**BEFORE HEARING COMMISSIONERS
FOR SELWYN DISTRICT COUNCIL**

Private Plan Change Request
71 (PC71)

**SUMMARY OF HEARING REPORT OF MR HUGH ANTHONY NICHOLSON
ON BEHALF OF SELWYN DISTRICT COUNCIL**

URBAN DESIGN AND LANDSCAPE

Figure 2: rev. 1 PC71 ODP - Rolleston
(with CIAL 50dBA noise contour)

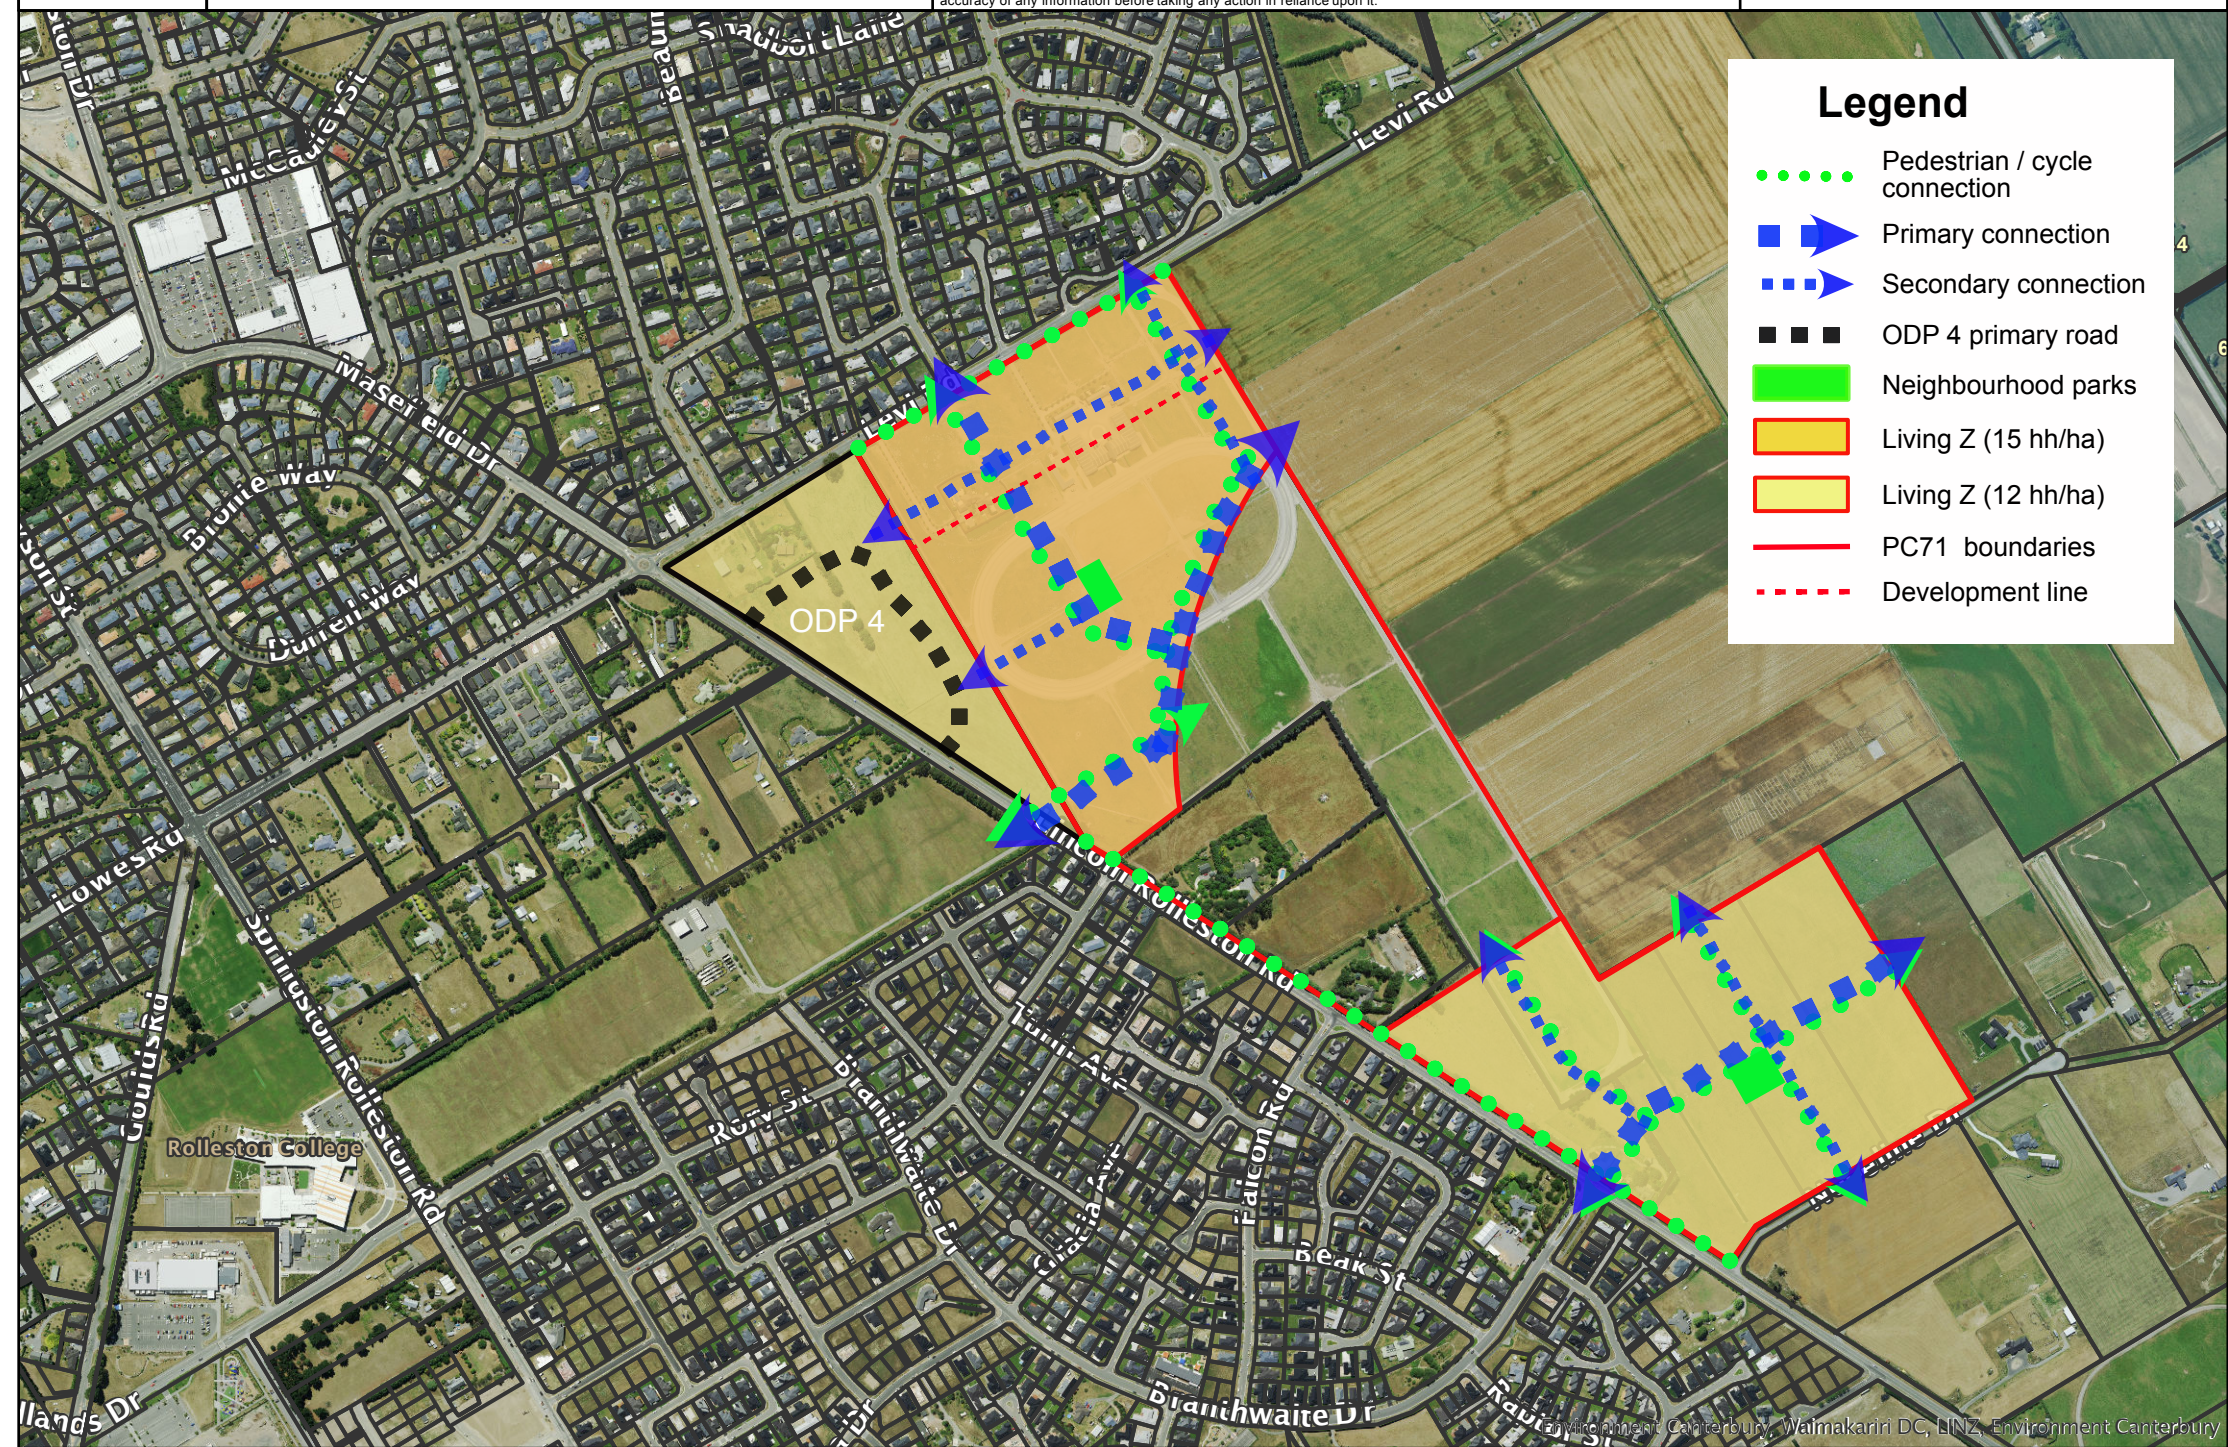
2.3 The revised ODP proposes a park in the area under the 50dBA noise contour together with a pocket park to service the northern half of the site with open space. I consider that it is not appropriate for new residential areas to rely on a neighbourhood park within a neighbouring rural zone given that even if the land is rezoned on a deferred basis, there is no certainty that the 50 dBA noise contour will be removed. I also note that CIAL is opposing the plan change and Ms White supports the retention of the rural zoning within the contour. In my opinion two neighbourhood parks should be located closer to the centres of the northern and southern residential areas to ensure that adequate green open space can be provided for the new residential areas which is not reliant on changes to the 50 dBA noise contour regardless of whether the land is rezoned on a deferred basis or not (see Figure 2 rev. 1).

2.4 While a separated shared pedestrian / cycle way is proposed along the Levi Road frontage, the ODP does not include a similar facility along the Lincoln Rolleston Road frontage. I acknowledge that there is a shared pedestrian / cycle path on the western side of Lincoln Rolleston Road, however, in my opinion expecting pedestrians or cyclists to cross a busy arterial road in order to reach a safe facility signals that they have a secondary status, and does not encourage or support alternative transport modes. I consider that it is not appropriate to rely on alternative pedestrian cycling routes under the 50dBA noise contour, and recommend that a separated shared pedestrian cycle way is provided along the Lincoln Rolleston Road frontage as part of the ODP in order to provide high quality pedestrian and cycling opportunities for the future residents of PC71 (see Figures 2 rev.1 and Figure 3 rev.1).
